RANCHO SANTIAGO COMMUNITY COLLEGE DISTRICT

ADDENDUM NO. 1

Bid #1413 BR Signage and Wayfinding
at
Santiago Canyon College

January 18, 2022

DRAWING TITLE:
SITE PLAN

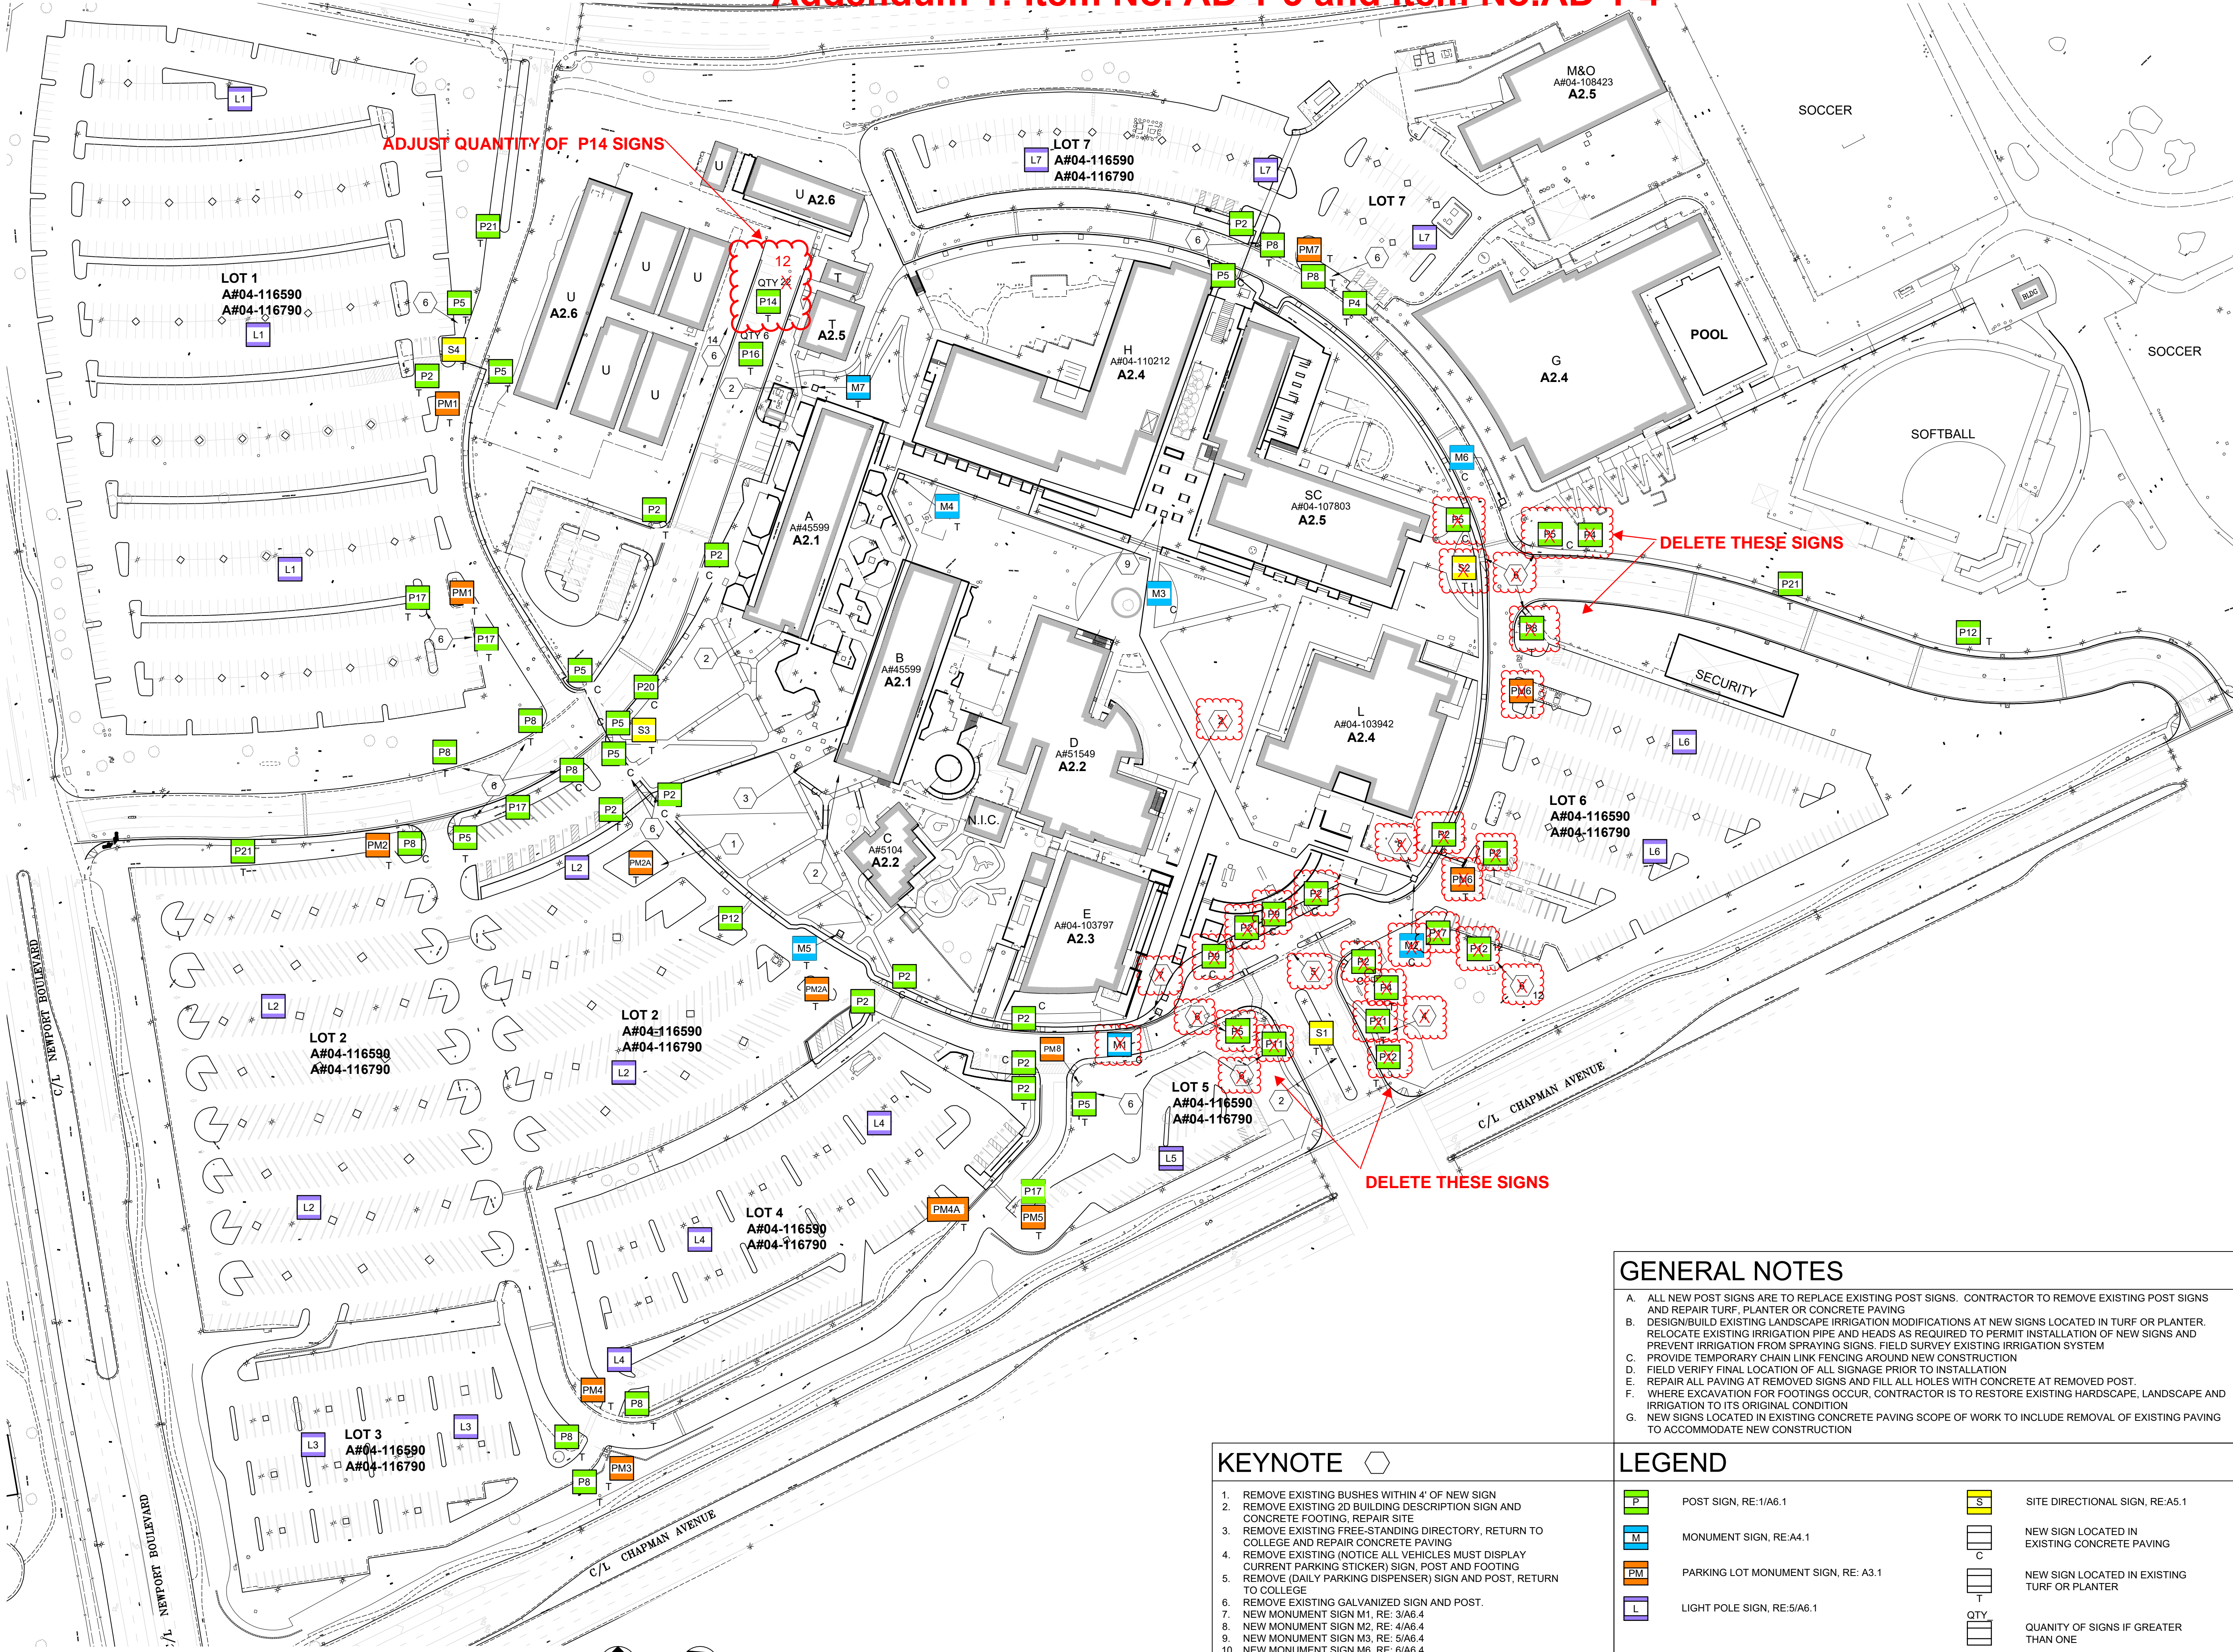
Question: On page A1.1 the quantity for P14 notes a total of (22) and P16 a total {6}.

Please advise if this is a typo or indeed if there is this many quantity of this sign type and if so, can it be illustrated correctly on the site plan for installation placement purposes.

Refer to attached Drawing A1.1, Site Plan. Modify as follows:

A. Delete the following signs at the south side of the campus:

M1, (1) M2, (5) P2, (2) P4, (3) P4, (1) P8, (2) P9, (1) P11, (13) P12, (1) P17, (1) P21, (2) PM6, and (1) S2.

B. Revise the quantity of P14 parking lot post signs south of Building U: (12) Twelve.

C. Delete the following Keynotes in conjunction with the noted delete signs at the south side of the campus:

(1) 2., (1) 4. (1) 5., (4) 6., (1) 7., and (1) 8.

Answer: P14 to be a total of (12) signs. P16 to be a total of (6) signs as indicated.
